REGIONAL REVIEW NOTIFICATION

ARC REVIEW CODE: R2111011

Name of Proposal: Kennemore DRI 3404

Description: A Development of Regional Impact (DRI) review of a proposal to build a mixed-use development on an approximately 140-acre site in unincorporated Forsyth County, north of Union Hill Road, east of Fowler Road, and south of Fowler Hill Road except for a small tract extending north of said road. The site is mostly undeveloped with about two-thirds previously cleared for agriculture and the remaining third natural forest. There are several wetlands and streams located within the site. The plan of development includes 234 single family detached residential lots, 272 attached townhome residential units, 22,211 SF of restaurant/retail space, and 32,080 SF of office space. Approximately 1,370 parking spaces are proposed. Forty-two acres will be retained as open space. Site access is proposed via two full-movement driveways on Union Hill Road, one full-movement driveway on Fowler Road, one right-in/right-out driveway on Mullinax Road, and aligning full-movement driveways to serve portions of the project on the north and south sides of Fowler Hill Road. The nearest state route is US 19/

SP-2

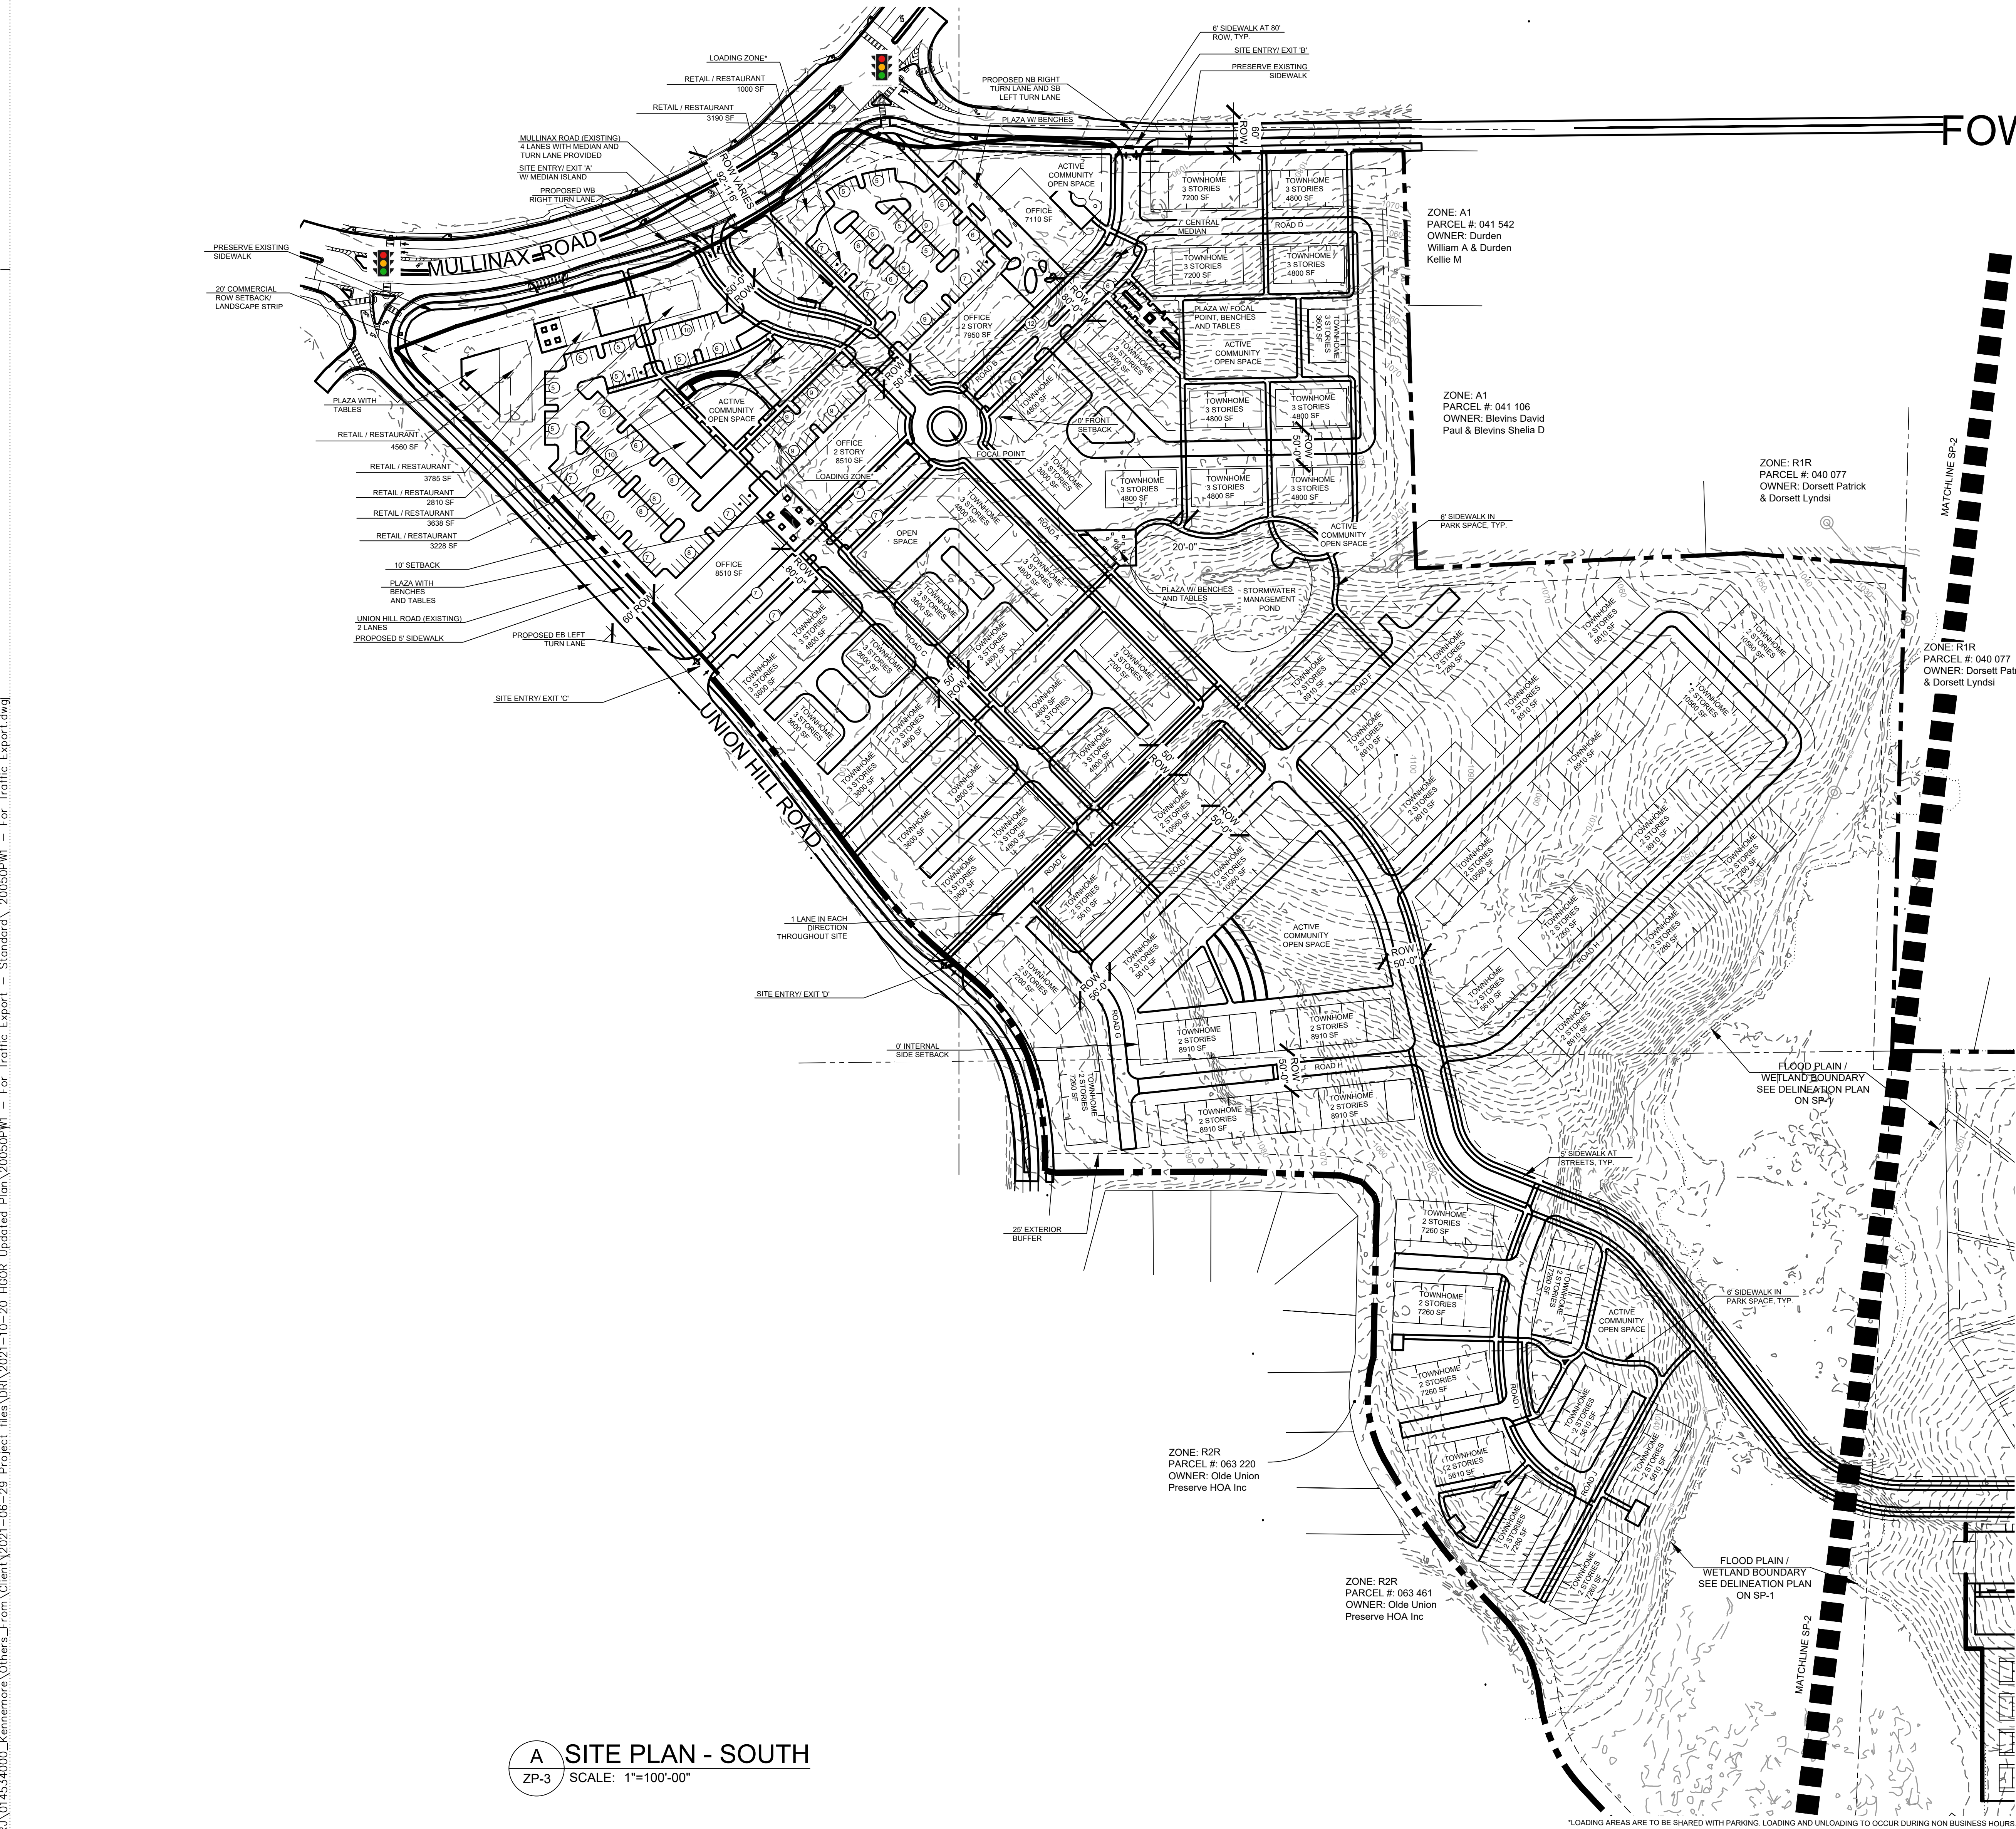
The Big Creek Greenway is a 12-foot-wide paved trail that stretches 26 miles and connects Cumming, Alpharetta, and Roswell. The applicant team indicated during the pre-review meeting for this project that plans are underway to potentially connect to the Greenway via a multi-use path or sidewalk along Fowler Hill Road to its eastern terminus, to a new path entrance point. This plan is indicated on the DRI site plan,

sheet 2. ARC supports this effort to enhance connectivity to this regional amenity. There is also an existing Greenway entrance located just a few blocks from the southeastern edge of the project site on Union Hill Road, but there is limited sidewalk infrastructure that connects to it from the closest DRI site driveways (C and D). Ideally the project's Union Hill frontage would include a sidewalk that could eventually link to the Greenway which provides a safe, off-road connection to dozens of destinations within biking and walking distance, including Forsyth County's 85-acre Fowler Park to the north and the mixed-use Halcyon community to the south.

The USGS coverage for the project area shows a blue-line tributary to Big Creek crossing the center of the project property which is not shown on the plan. Four wetland areas and three intermittent streams are generally located on the plan, but their exact limits and the buffer areas associated with them are not shown. As a result, it is unclear if elements of the proposed project intrude into the buffers. All riparian elements and their associated buffers should be shown in a clear manner, and any intrusions into buffers should be noted. The proposed road crossing connecting the two halves of the property is exempt from the County buffer requirements. Any other buffer intrusion not exempted under the County stream buffer ordinance may require a variance from the County. Any other unmapped streams on the property may be subject to County stream buffer requirements.

The USGS coverage for the project area shows a blue-line tributary to Big Creek crossing the center of the project property. While the stream is not shown on the site plan, the stream floodplain and associated wetlands are delineated. No stream buffers are shown. While the floodplain appears to extend beyond the Forsyth County 50-foot stream buffer and 75-foot impervious setback, they should be shown on the plans, along with the 25-foot State erosion and sedimentation buffer. The only intrusion into the floodplain that may affect the buffers is the proposed road crossing connecting the two halves of the property. Transportation crossings are exempt from the County buffer requirements. Any other buffer intrusion not exempted under the County stream buffer ordinance may require a variance from the County. Any other unmapped streams on the property may be subject to Forsyth County stream buffer requirements. All state waters on the property will be subject to the 25-foot State Erosion and Sedimentation Act buffers.
